CHANGE REQUEST

⌘ **24.008 CR** ⌘ rev **-** ⌘ Current version: **4.1.1** ⌘

Title:	⌘ Modification to MS's MM states to enable LCS signalling on RR layer		
Source:	⌘ Nokia		
Work item code:	⌘ LCS	Date:	⌘ 07.03.2001
Category:	⌘ A	Release:	⌘ REL-4
	Use <u>one</u> of the following categories: F (essential correction) A (corresponds to a correction in an earlier release) B (Addition of feature), C (Functional modification of feature) D (Editorial modification)		Use <u>one</u> of the following releases: 2 (GSM Phase 2) R96 (Release 1996) R97 (Release 1997) R98 (Release 1998) R99 (Release 1999) REL-4 (Release 4) REL-5 (Release 5)
	Detailed explanations of the above categories can be found in 3GPP TR 21.900.

Additions to Figure 4.1.a/GSM 04.08

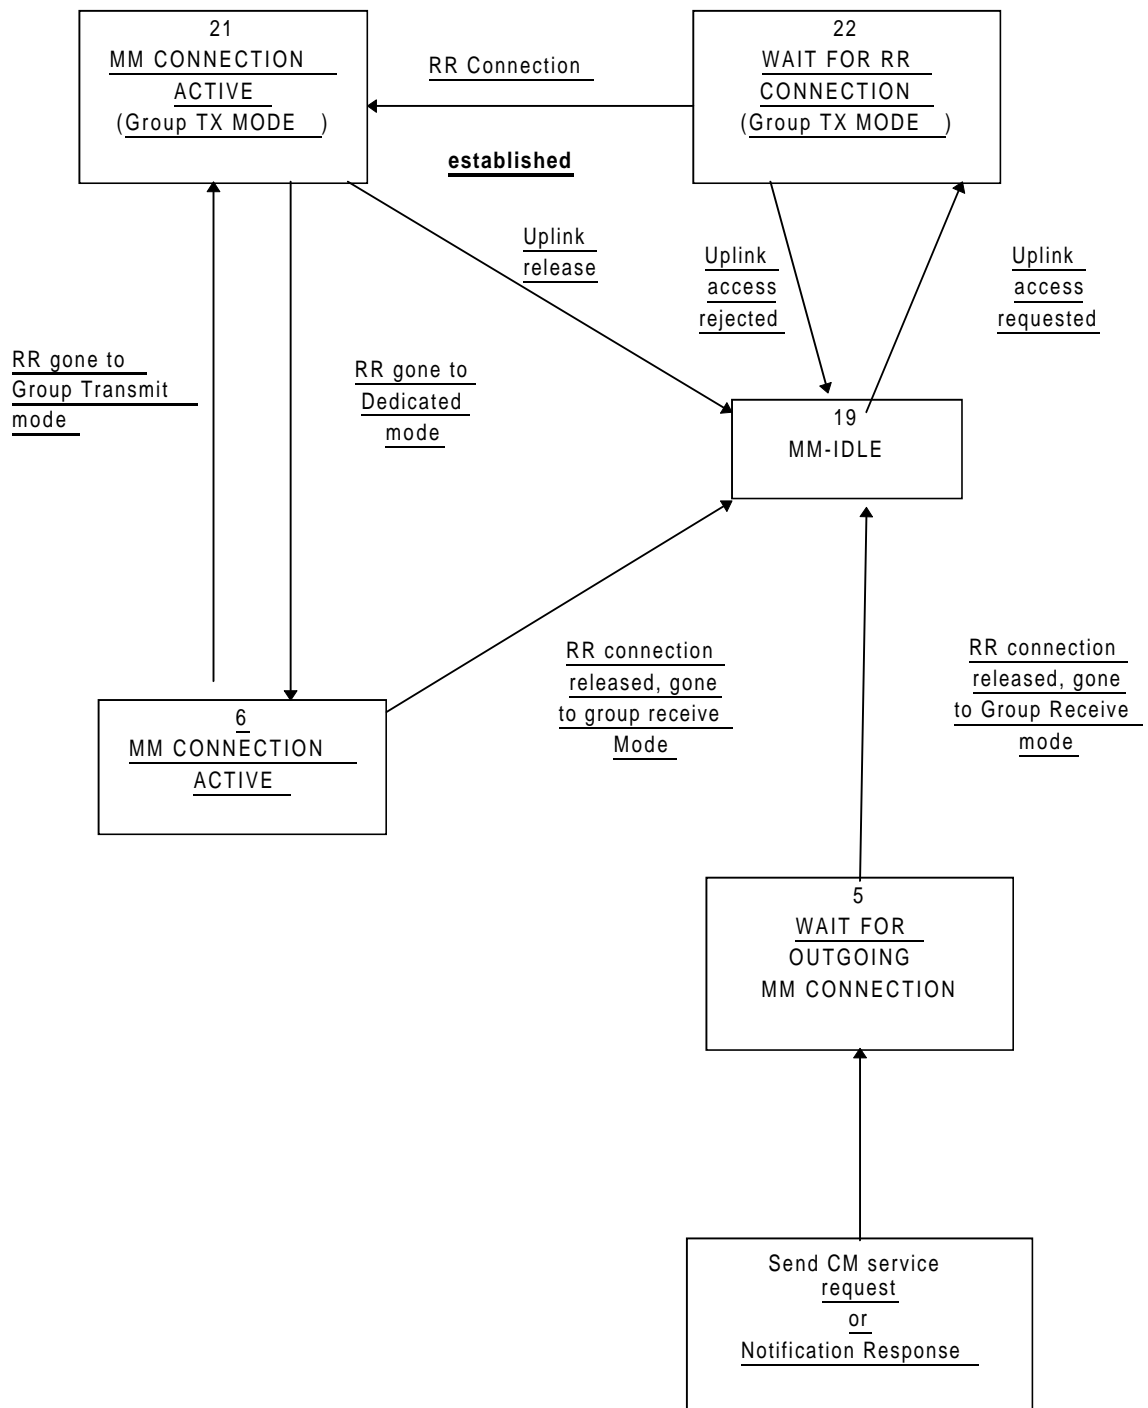
Reason for change:	⌘ LCS communication occurs in RR layer. For MT-LR/NI-LR case the MM layer is not active (from MS point of view) after authentication which causes that RR connection will be closed even if RR is needed for LCS signalling. The connection is closed by MS via T3240 timer within 10 seconds after last MM interaction. The LCS signalling may take longer than 10 seconds. This correction enables to stop T3240 timer and transit to a new MM state when RR layer sends indication to MM layer using RR-No-Abort-Ind (no abort) RR-SAP service primitive. The return to the normal MM operation occurs when RR-No-Abort-Ind (abort allowed) RR-SAP service primitive is received from RR layer. A new timer T32xx is added to guard the new MM state. This change together with CR to 04.07 (addition of RR-No-Abort-Ind primitive at RR-SAP in MS side) will correct the problem.
Summary of change:	⌘ The definition of a new MM state RR CONNECTION RELEASE NOT ALLOWED is added and the state transitions to/from the new state are defined. A new timer T32xx is defined.

25. RR CONNECTION RELEASE NOT ALLOWED

(Only applicable for MSs supporting LCS) There is no MM procedure running but RR connection exists. The timer T32xx is running.

When in state WAIT FOR NETWORK COMMAND, RR CONNECTION RELEASE NOT ALLOWED state is entered, if RR-No-Abort-Ind (no abort) has been received (in this or any of the other MM states).

In above state transition, timer T3240 is stopped and reset but not restarted. Timer T32xx shall be started.
